CITY OF SAN ANTONIO

Re: Rolling Meadows

MDP # 760A

The City Staff Development Review Committee has reviewed the Rolling Meadows Master Development Plan, M.D.P. # 760A. Please find enclosed a signed copy for your files. Your plan was accepted, however please note the following:

ROLLING MEADOWS
 SAN ANTONIO, TEXAS
 MASTER DEVELOPMENT PLAN

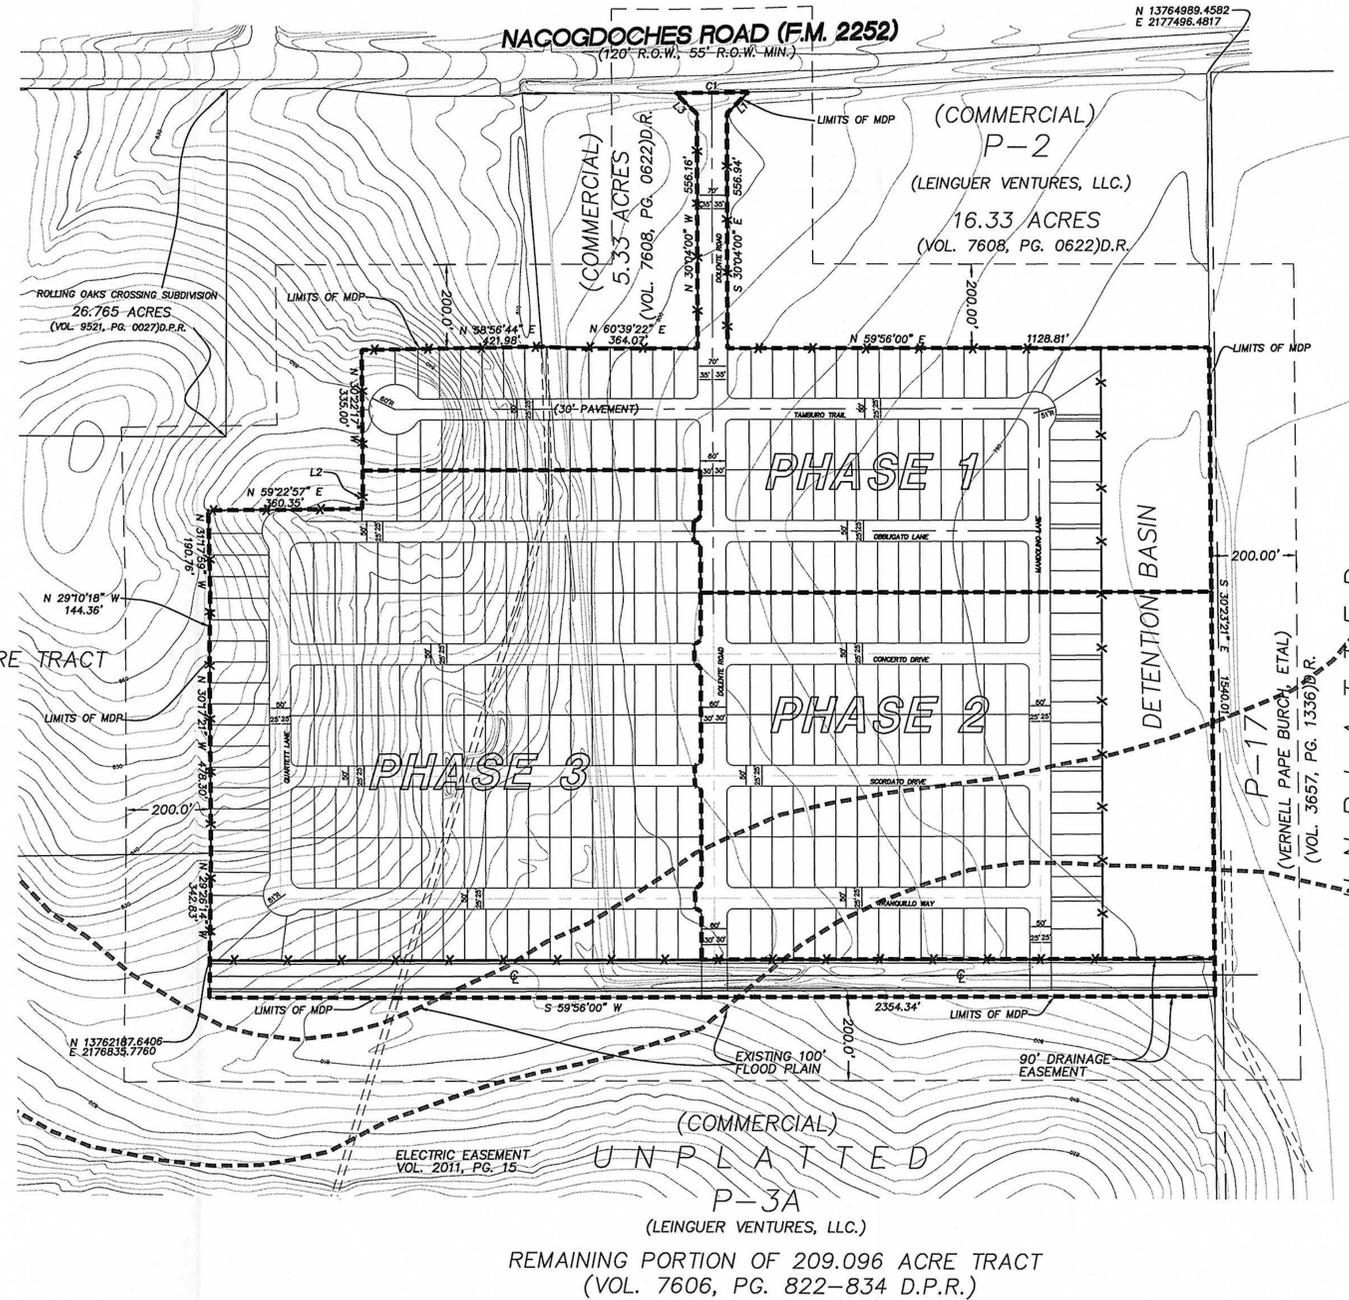
- In consideration of public safety and convenience, excessive grades by reason of topography should be avoided in street layouts and arrangements.
- Any access and R.O.W. issues along state facilities will need to be resolved with the Texas Department of Transportation (TXDOT). For information about these requirements you can contact TXDOT at 615-5814.

- It will be expected that you will plat all of the property depicted in your Master Development Plan (M.D.P.) to include floodplains, drainage areas and open space.

1. Pre-Development % of Impervious Cover will be required at the platting stage.
2. Clarification of the 21.55 Acres of Lewisville silt clay will be required at the platting stage.

3. During the platting stage, a drainage study with a drainage area map showing the path of Tc will be required. This is to verify the overland flow of 20 min. in both Pre and Post Conditions.

1. A right-turn deceleration lane shall be installed for northbound Nacogdoches Road at the main entrance to this subdivision.
 2. The City of San Antonio recommends the installation of a left-turn lane for the main entrance on southbound Nacogdoches Road.
- The Parks and Recreation Department as part of their conditional approval impose the following:
 1. Rolling Meadows is a proposed subdivision of 365 residential units. UDC Section 35-503 requires 1 acre of parkland for every 114 residential units. Rolling Meadows has a park dedication requirement of 3.3 acres of parkland or the equivalent fee in-lieu of dedication.
 2. Prior to the recordation of the first plat filed under this Plan, a fee in-lieu of dedication in the amount of \$20,475.97 is to be paid to the Parks and Recreation department for the remaining dedication requirement of 3.3 acres.
